State of New Mexico
Energy, Minerals and Natural Resources

SUNDRY NOTICES AND REPORTS ON WELLS
(DO NOT USE THIS FORM FOR PROPOSALS TO DRILL OR TO DEEPEN OR PLUG BACK TO A DIFFERENT RESERVOIR. USE "APPLICATION FOR PERMIT" (FORM C-101) FOR SUCH PROPOSALS.)

PERFORM REMEDIAL WORK ☐ PLUG AND ABANDON ☒
TEMPORARILY ABANDON ☐ CHANGE PLANS ☐
PULL OR ALTER CASING ☐ MULTIPLE COMPL ☐
DOWNHOLE COMMINGLE ☐
CLOSED-LOOP SYSTEM ☐
OTHER: ☐

Myox 6 State Com #12H
 Hay Hollow, Bone Spring
 Eddy County

CURRENT WELL SKETCH

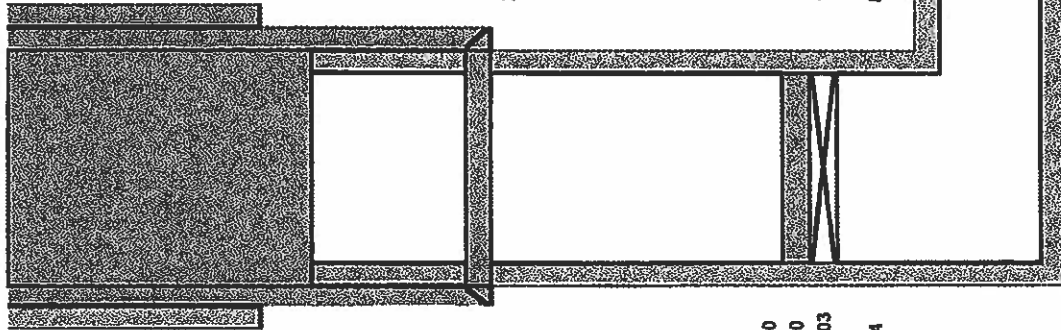
- 60
- Set 5 1/2" CIBP @ 5800'. Circ well w/ MLF. Pressure test csg. Spot ~~25~~ sx cmt @ 5800-5800'. WOC & tag - Must tag @ 5300'
 - Perf & Sqz 60 sx cmt @ 2331-2085'. WOC & Tag (9 5/8" csg & B/Salt)
 - Perf & Sqz 110 sx cmt @ 500' to surface. (T/Salt & 13 3/8" Shoe)
 - Cut off well head, verify cmt to surface, weld on Dry Hole Marker. Must wait 4 hrs after cmt before cut off

MUST BE PLUGGED BY 3/18/2022
